LVIA ANALYSIS OF THE REQUEST FOR FURTHER INFORMATION

LVIA INVESTIGATIVE EXERCISE

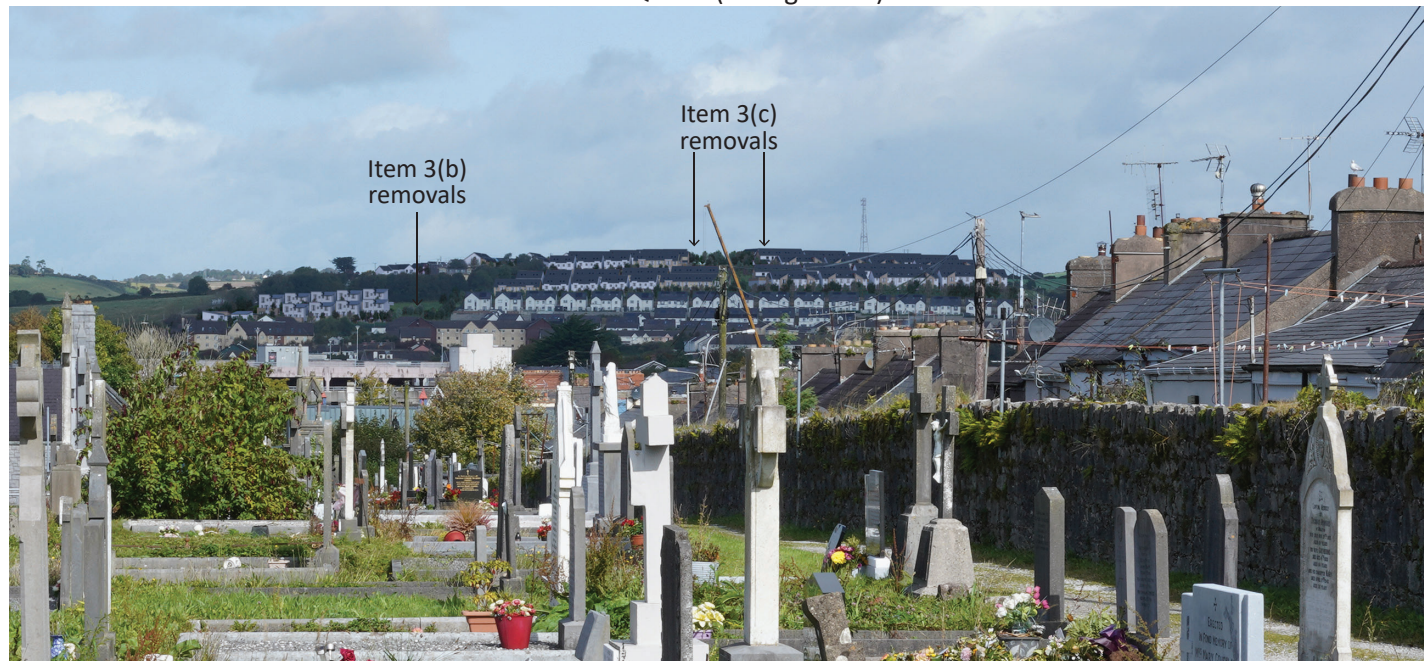
Part 3(b) - The original scheme provided a gap between the duplexes and existing Blossomhill estate (to the right). The omitted duplexes make this gap more pronounced, but the enlarged green space is still surrounded by development. The removals do not mitigate the change from a greenfield site to a zoned residential parcel. The omissions would result in no change to overall LVIA impact. However, an increased woodland buffer between the duplexes and Blossomhill would be welcome to improve visual separation between the two.

Part 3(c) - The omitted 18 no. houses sit to the back of the hilltop and are virtually imperceptible when removed. There is a miniscule visual change behind the amenity spine and is one that will disappear as the intervening trees mature. The recommended omissions are unnecessary from an LVIA perspective.

Part 3(b) - The omitted duplexes result in a slightly larger visible gap to the Blossomhill estate. At the upper duplex, removal of units results in a visual replacement by background houses, so the change is negligible. The recommended removals occur embedded within the scheme and the omissions results in no change to LVIA impact.

Part 3(c) - 18 no. houses have been omitted from the northern part of the site and in this instance the removals are not perceptible. There is no change to the ridgeline of houses, as the foreground houses and trees remain as designed and are the ones that form the new ridgeline. The recommended omissions are unnecessary from an LVIA perspective.
